CITY OF CODY
PLANNING, ZONING AND ADJUSTMENT BOARD AGENDA
TUESDAY, FEBRUARY 28, 2023
CITY HALL COUNCIL CHAMBERS @ 12:00 NOON

**CITY OF CODY
PLANNING, ZONING AND ADJUSTMENT BOARD
STAFF REPORT**

MEETING DATE:	FEBRUARY 14, 2023	TYPE OF ACTION NEEDED	
AGENDA ITEM:		P&Z BOARD APPROVAL:	
SUBJECT:	FINAL PLAT AND CONSTRUCTION PLANS FOR THE SUNRIDGE SUBDIVISION—AN 5-LOT SUBDIVISION. SUB 2022-04	RECOMMENDATION TO COUNCIL:	X
PREPARED BY:	TODD STOWELL, CITY PLANNER	DISCUSSION ONLY:

DATE	DRAWING LOG	BY	CHECKED	APPROVED	DRAWN BY: IKSM	OWNER:	PROJECT:	SHEET
5/5/22	ORIGINAL DRAWING	IKSM			JOB NO. 22002.00	SHELLY CATE & RYAN SILVA	SUNRIDGE MINOR SUBDIVISION	7 OF 11
					FIELD BOOK NO. 593		PLAN & PROFILE - PATHWAY

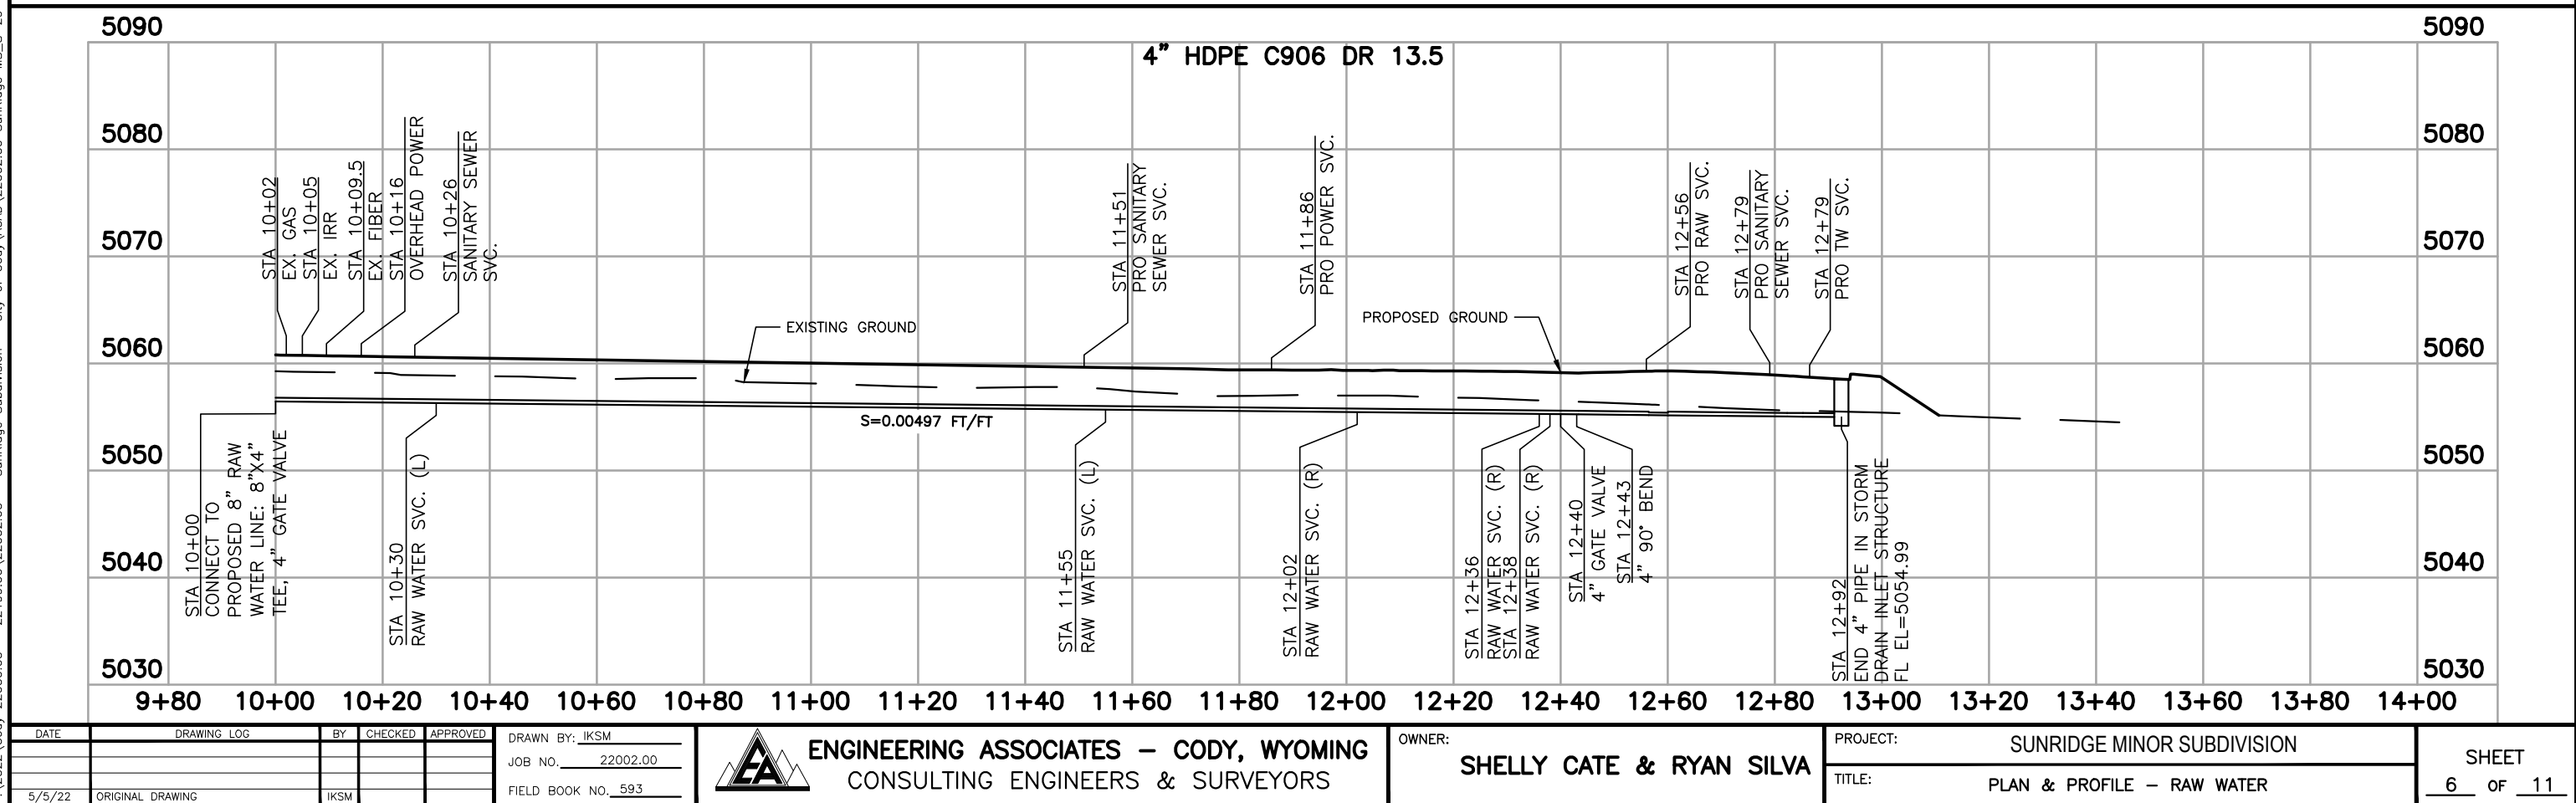
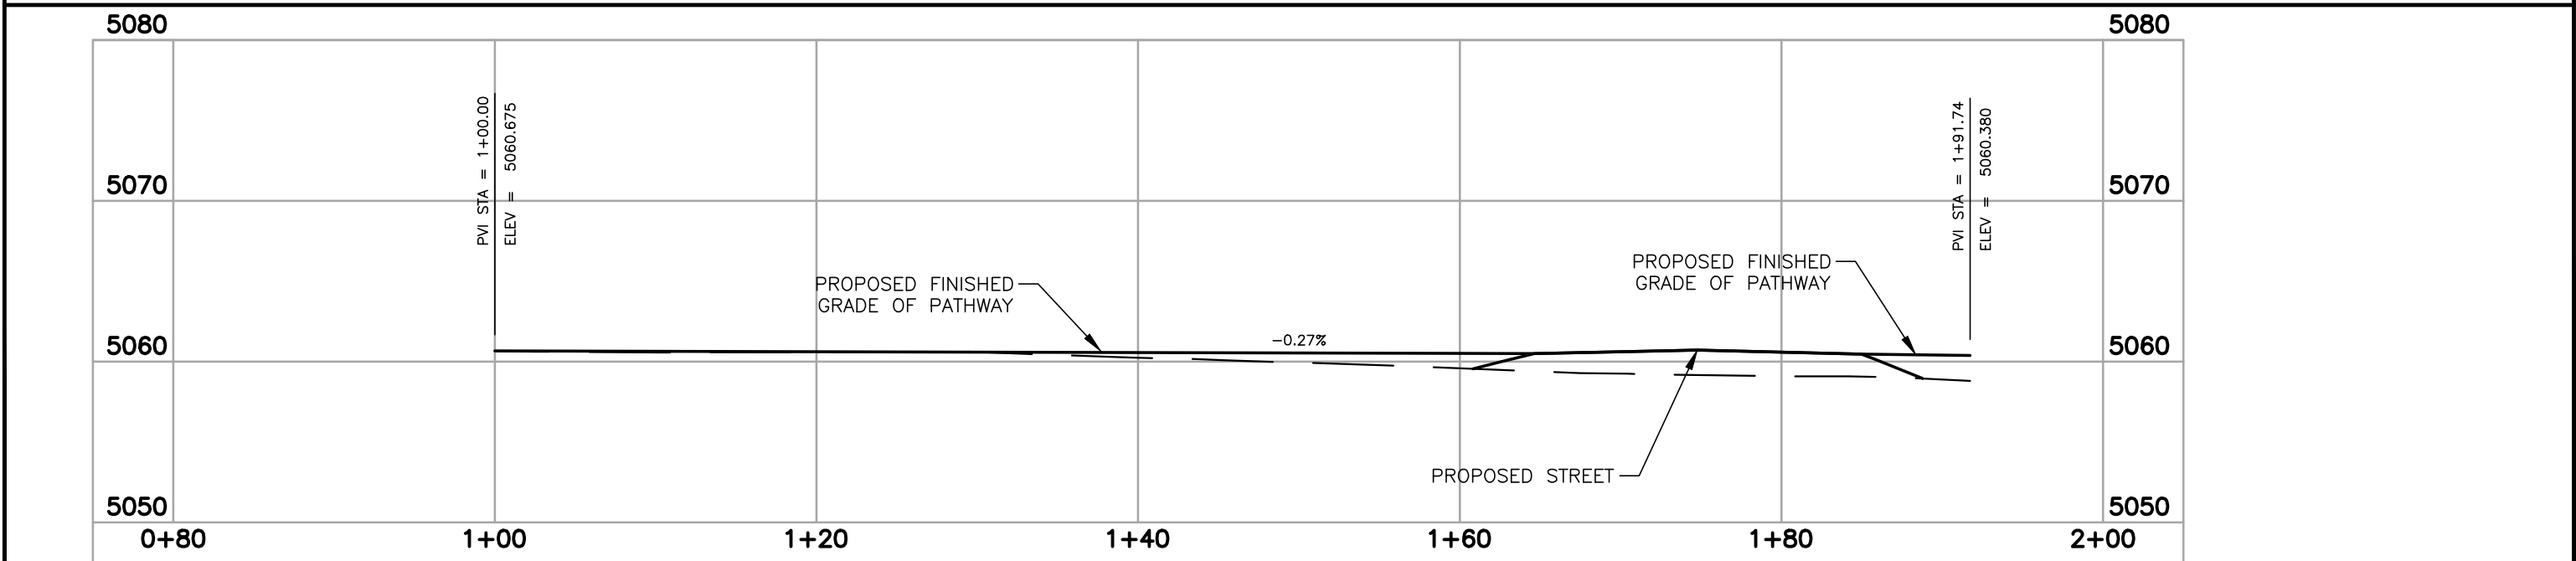
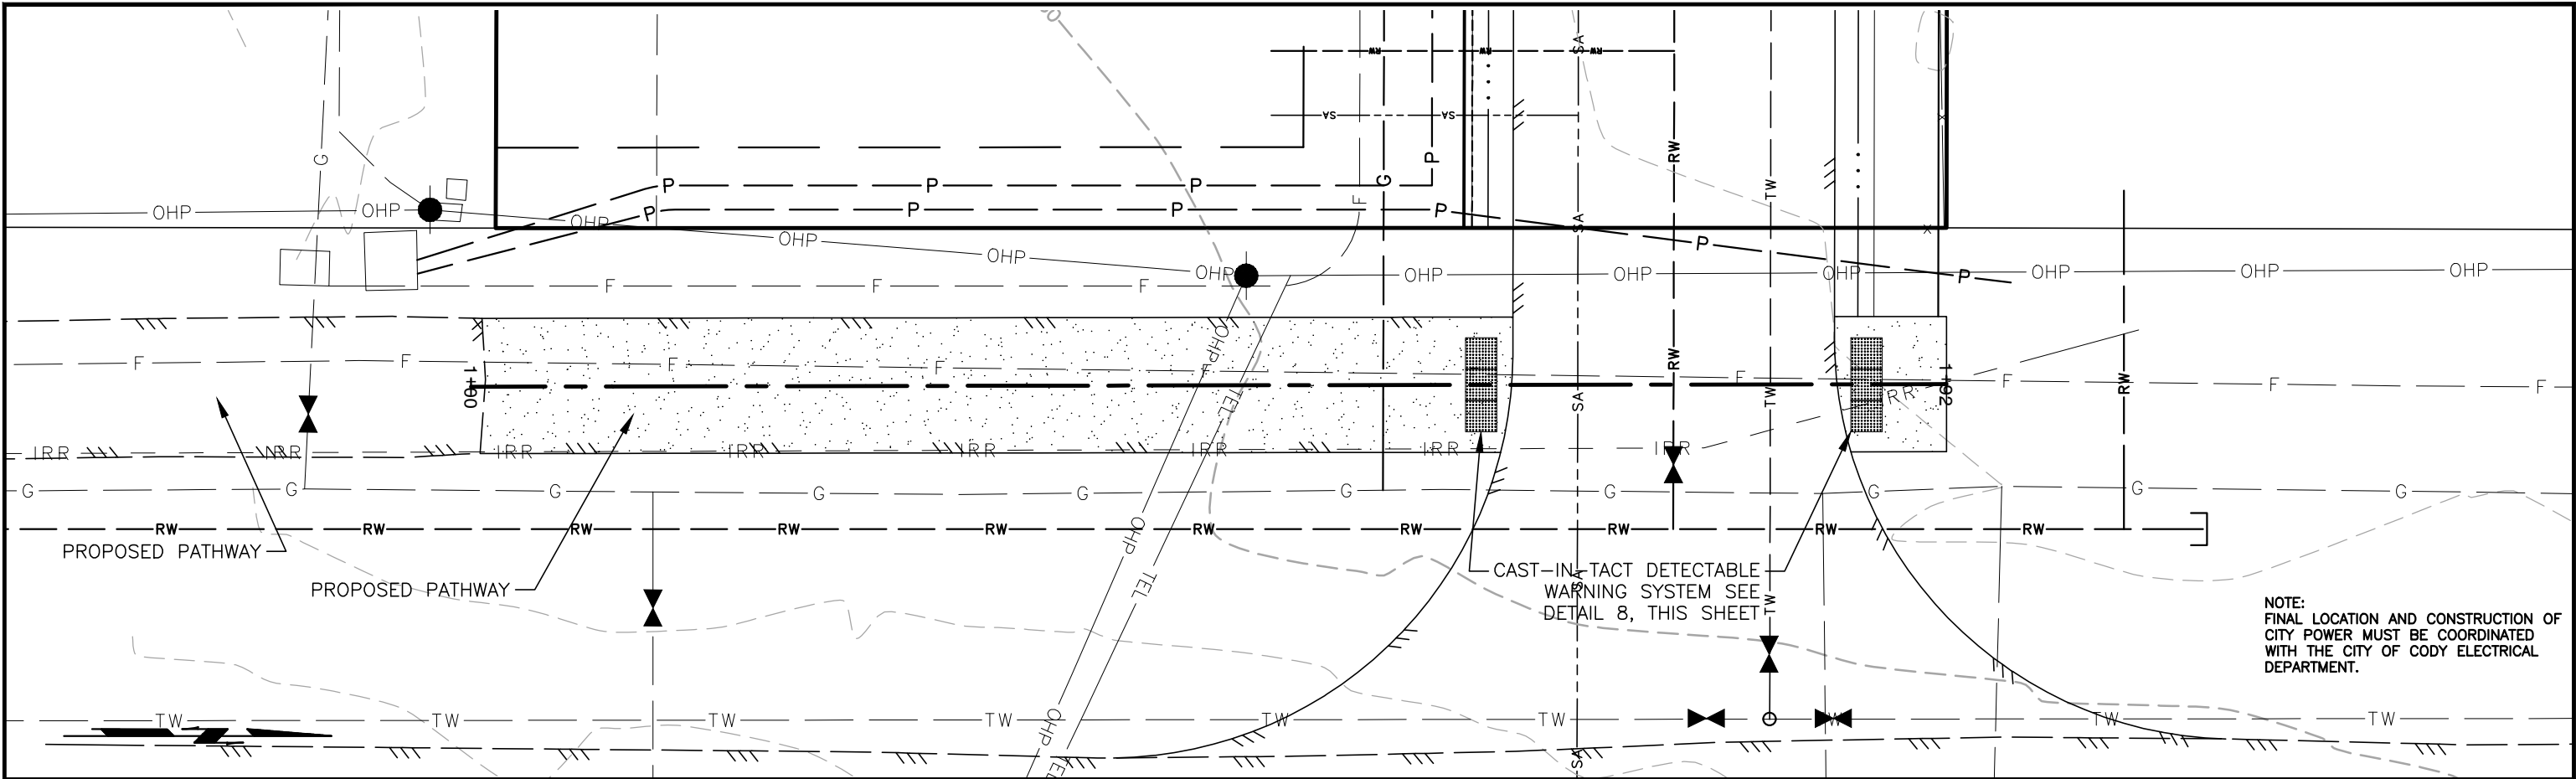
- m) *Coordinate the street design with the pathway design. Met---see Sheet 7 of plans.*
 - n) *List the variances granted on the final plat. Not met—need to add.*

6. *Install an 8-foot-wide asphalt pathway along the property frontage of 29th Street or pay that amount to the city prior to recording the final plat.*
Status: Not met. The current plan is to have the pathway installed when the internal street is paved. So long as the pathway along the subdivision frontage is installed before the rest of the 29th Street pathway to the north is installed by the City, there will be no gap in the pathway. To allow the applicant the option

of having their contractor complete the paving, it is proposed that they make a security deposit in the estimated cost to the City to hold as assurance that the completed as planned. The deposit would be provided before the first building permit is issued in the subdivision (anticipated to be to the owner, for Lot 2). As long as the pathway construction is completed by the subdivider as specified and before the City project commences, the funds would be returned. If it is not completed before the City project commences, the City would do the work and the security deposit would be claimed by the City as payment for the portion of the project along the subdivision frontage. The security deposit has been calculated to be \$2,600.00.

SHEET
8 OF **12**

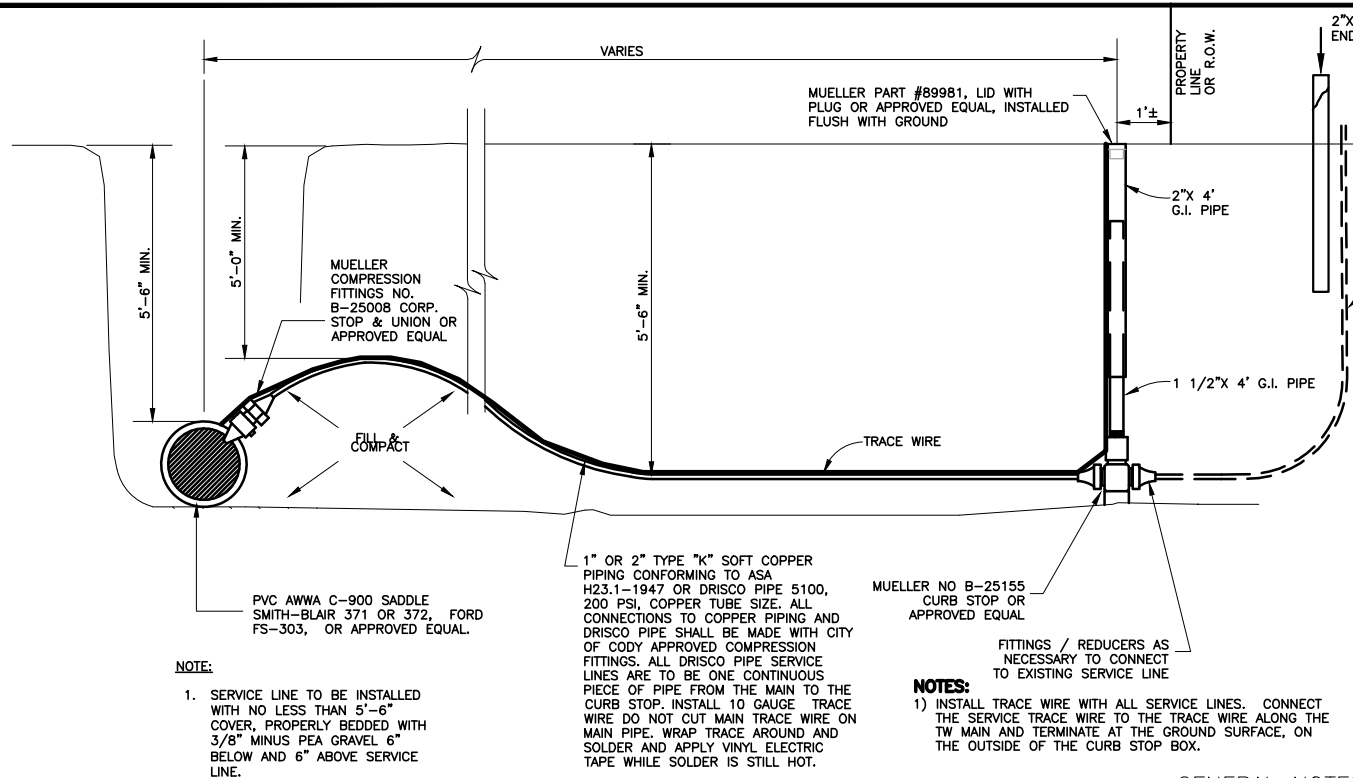
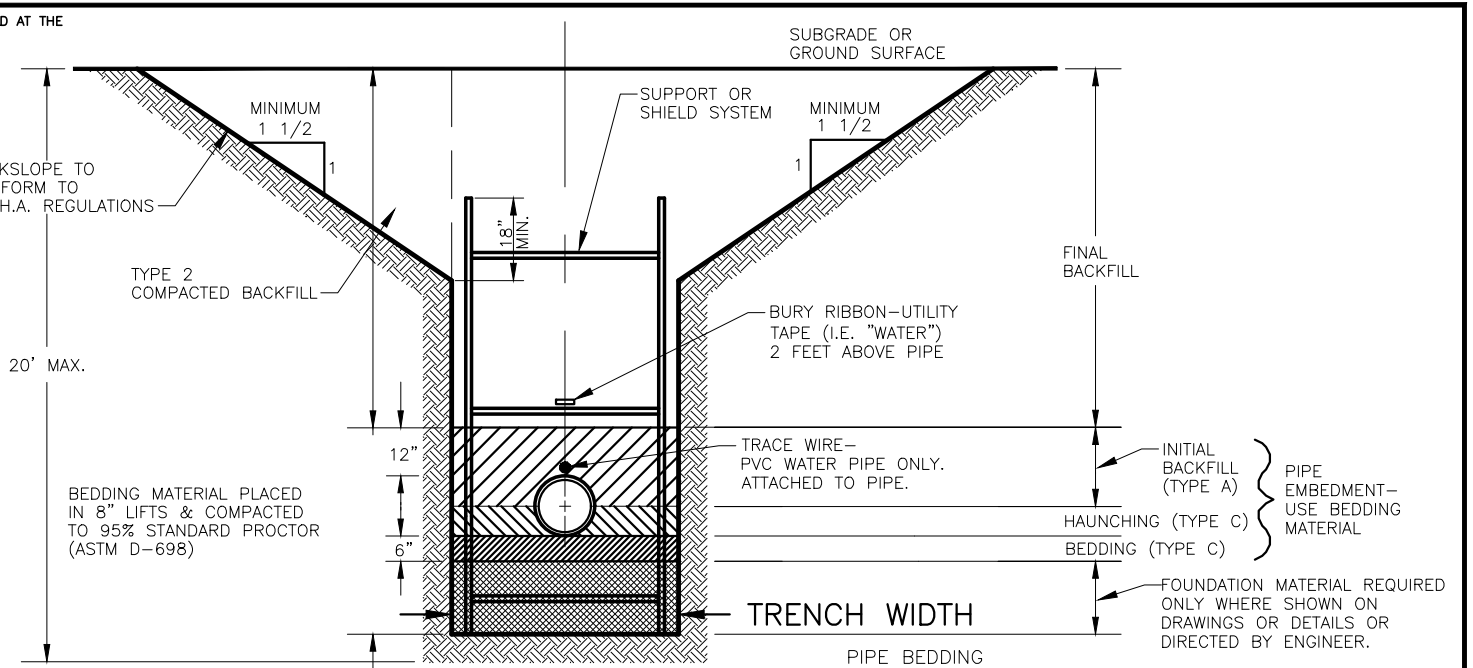
- h) *Provide a cross section detail for the street and utilities. Met—see Sheets 2 and 8-12.*
 - i) *In order to avoid having to dig under the dry utilities to connect to the water service stubs, extend a "pigtail" from the curb stop at the back of the sidewalk (or curb if no sidewalk) under the dry utility trench. Include a detail in the construction plans. Met—see Sheet 8.*

PRELIMINARY PLAT OF CASE MINOR SUBDIVISION

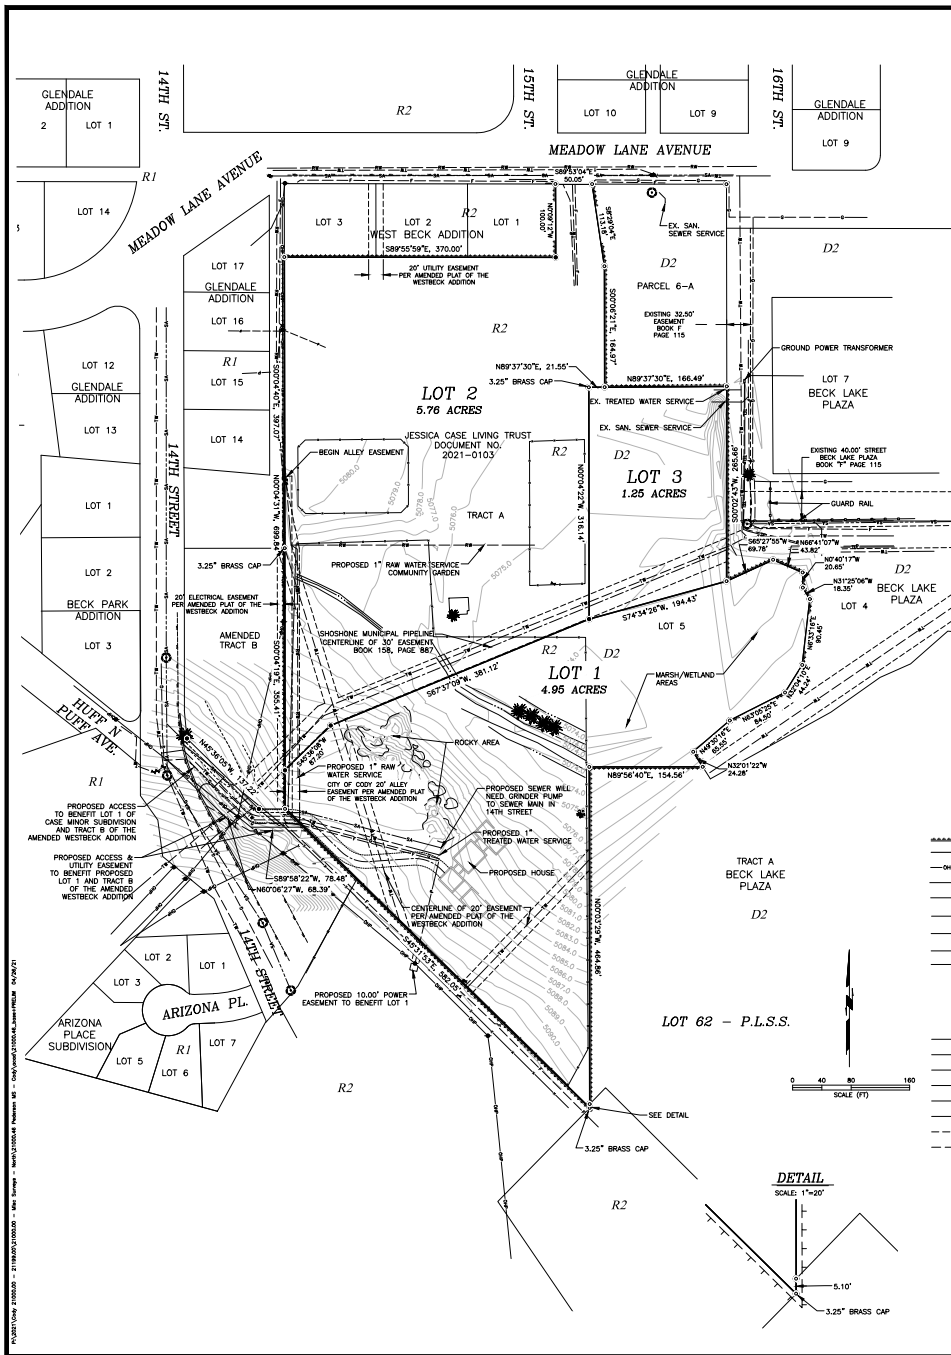
Comment: Will be met as proposed. Lot 3 has direct access to Meadow Lane Avenue. Lot 2 has legal access to an existing street to the east (unnamed). Lot 1 will need an access easement from the City to have access to 14th Street. The plan is to have the applicant and City negotiate the language of the easement and present it with the final plat for review.

Comment: All utility services are already into Lot 2. Lot 3 has all utility services except raw water. An easement should be provided over the owner's Parcel 6-A to provide Lot 3 with access to the raw water main along Meadow Lane Avenue. The general plan for serving Lot 1 with power, sewer, treated water, raw water, gas, and telecommunications is indicated on the preliminary plat, and acceptable to City staff. The final plat application will need to include the gas and telecommunication agreements noted for Lot 1. The utility easement to access the power pole for Lot 1's electrical service will also need to be provided.

Comment: Staff can't quite tell if the phone pedestal near the southwest corner of Lot 1 is in the way of the proposed access road. Verify the situation and coordinate any relocation of the phone pedestal with the utility provider as needed.

1. The applicant's engineer is to provide a design of the entrance road for review and approval with the final plat. The design must reasonably improve the angle where the road meets 14th Street. If the phone pedestal is in the way, coordinate relocation with the utility provider and Public Works.

2. Provide easement documents for the access road and utilities to Lot 1. (Two easements—the main easement and the electrical easement to the east).
3. Coordinate with the fire marshal and City Public Works on how the fire hydrant requirement will be met—install a hydrant at 14th Street, or install a fire sprinkler system in the house on Lot 1 and obtain a variance from the fire marshal for the distance from the hydrant.
